MEMORANDUM FOR RECORD 22 January 1990

SUBJECT: DECISION ON THE SUITABILITY OF DREDGED MATERIAL TESTED UNDER PSDDA CRITERIA FOR THE U.S.COAST GUARD/PIER 35 DREDGING PROJECT (OYB-2-012941) TO BE DISPOSED OF AT THE ELLIOTT BAY OPEN WATER DISPOSAL SITE.

Figure 2
Plan View
U.S. Coast Guard/Pier 35
Dames & Moore

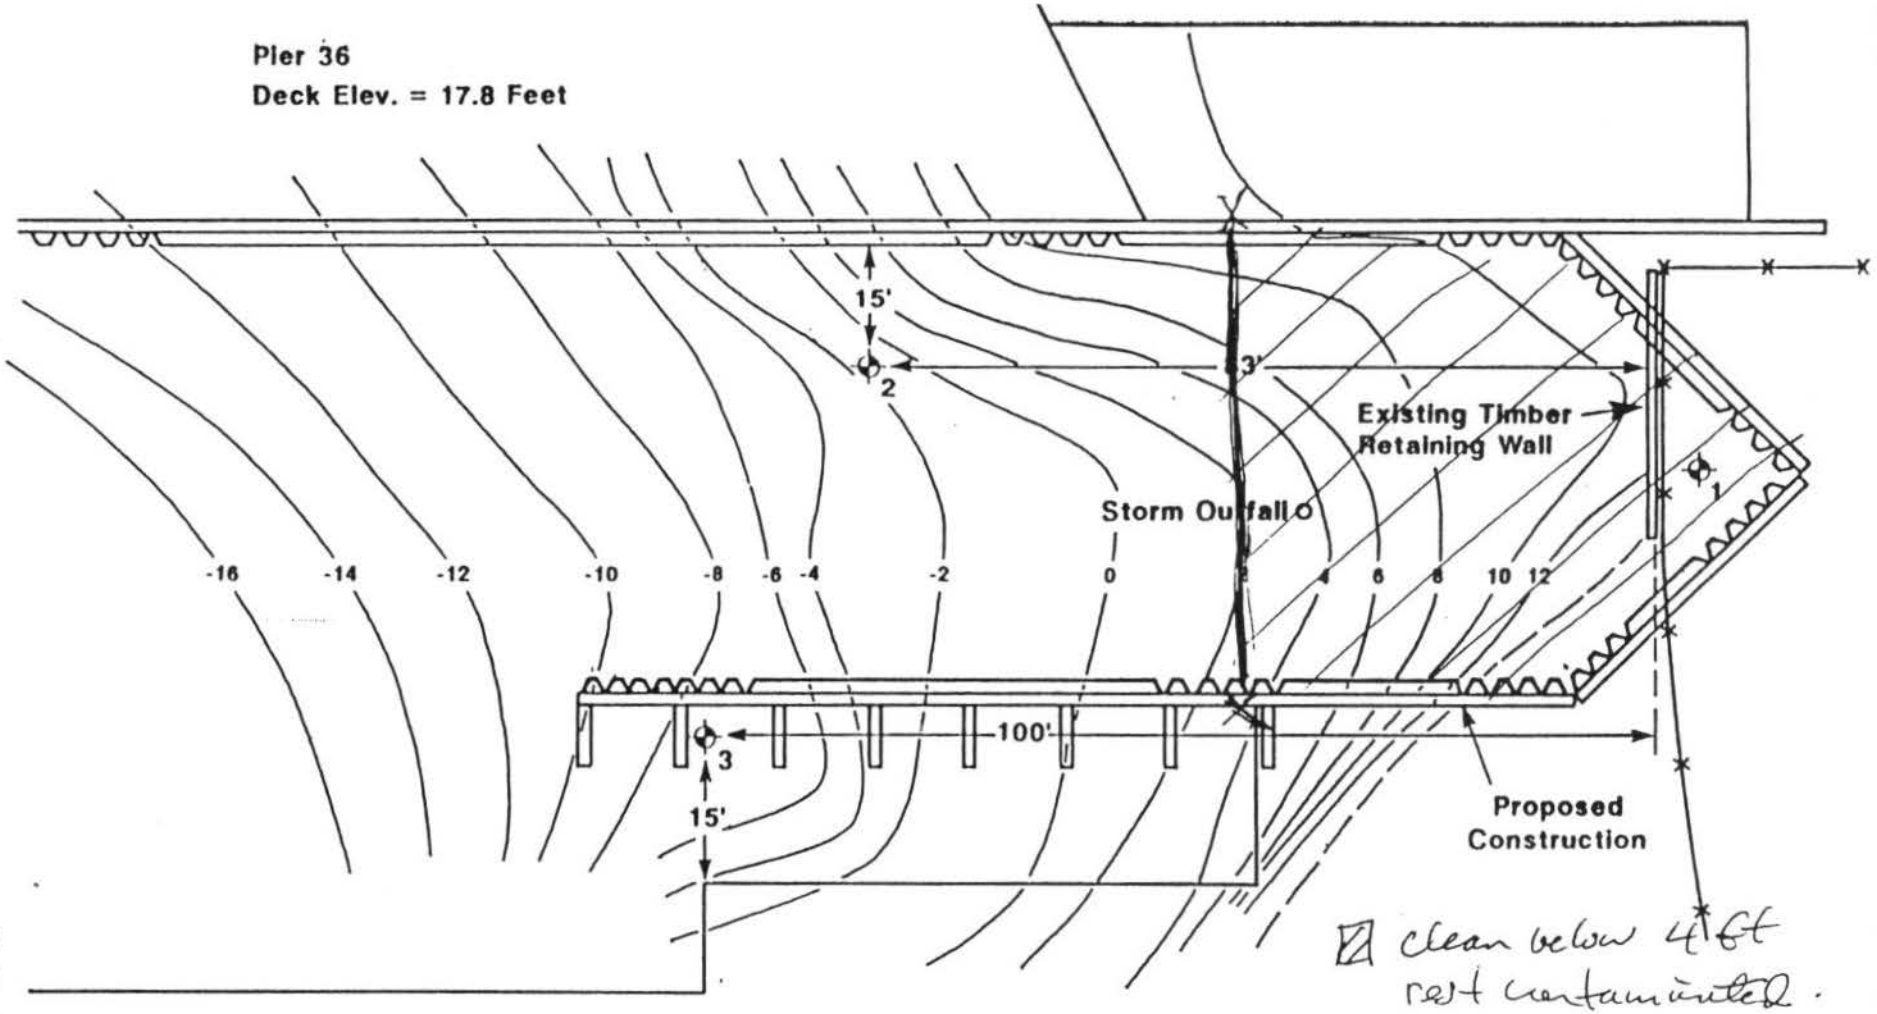
☒ clean below 4 ft
rest contaminated.

All material seaward of line contaminated. TOP 4 feet of ALL material landward of line contaminated. Material below 4 ft suitable for open water uncontrolled Disposal

5. Based on the above discussion and summary of chemical and bioassay results for the U.S. Coast Guard Pier 35 Project area, the PSDDA agencies concluded that 2700 cubic yards of potential dredged material was suitable for unconfined open water disposal at the Elliott Bay PSDDA disposal site, whereas 2400 cubic yards of material was found to be unsuitable for openwater unconfined disposal (see enclosure 2).
